# Service Advisory

MTD-040A

## (Walk Behind Mower - Self Propelled)

**Models Affected:** Single and Variable Speed Self Propelled Walk Behind Mowers  
**Serial Number Range Affected:** 2006 Model Year Production  
**Date:** 7/12/2006  
**Subject:** Operator's Manual Misprint & 753-0833 and 753-05096A Speed Control Kits

**FIGURE 1**

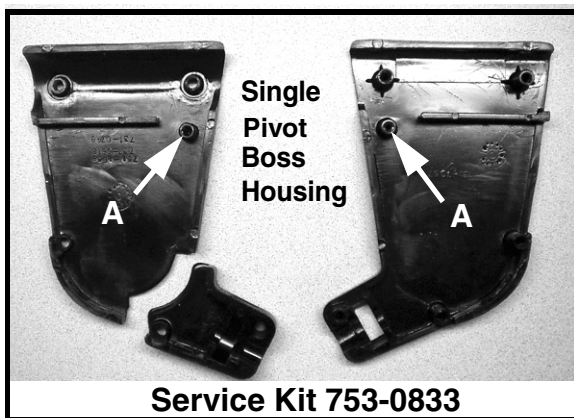
The purpose of this advisory is to clarify a misprint in some 2006 model year Operator's Manuals for the variable speed self propelled walk behind mowers having the control box style wheel drive control as shown in Figure 1.

The Operator's Manual for some 2006 Model year 500 series variable speed self propelled mowers call for the 753-0833 for the speed control assembly. This is in error and should be 753-05096A.

**FIGURE 2A**

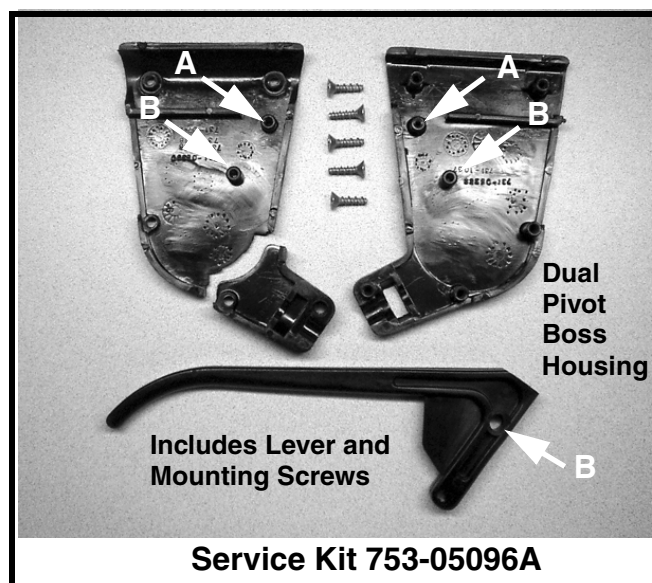
There are two service kits, **753-0833** and **753-05096A**, applicable to single and variable speed self-propelled walk behind mowers. Service Kit 753-0833 differs from 753-05096A in contents, parts configuration and application. Refer to Figures 2A and 2B.

The **753-0833** kit is applicable to 2005 and earlier single speed and variable speed units having the control box style speed control. The only exception is for the 2005 model year 800 Series variable speed units which should use Service Kit **753-05096A**. The **753-05096A** kit is applicable to 2006 model year and later single speed and variable speed units having the control box style speed control. Use of the **753-05096A** service kit on 2005 and earlier models is not recommended, except for 800 Series variable speed units, due to possible cable length and/or drive operational issues.

The **753-05096A** kit uses the 731-05388 control lever. This lever has an increased mechanical advantage as a result of moving the lever's pivot point from the "A" to "B" pivot boss. Therefore, the 731-05388 lever required the modification of the control housing. See Figure 2A and 2B for housing configuration differences. See Figure 3 for a comparison of the production levers.

**The 731-0620A lever can only be used with the 753-0833 Service Kit single pivot boss housings.**

**The 731-05388 lever can only be used with the 753-05096A Service Kit dual pivot boss housings.**
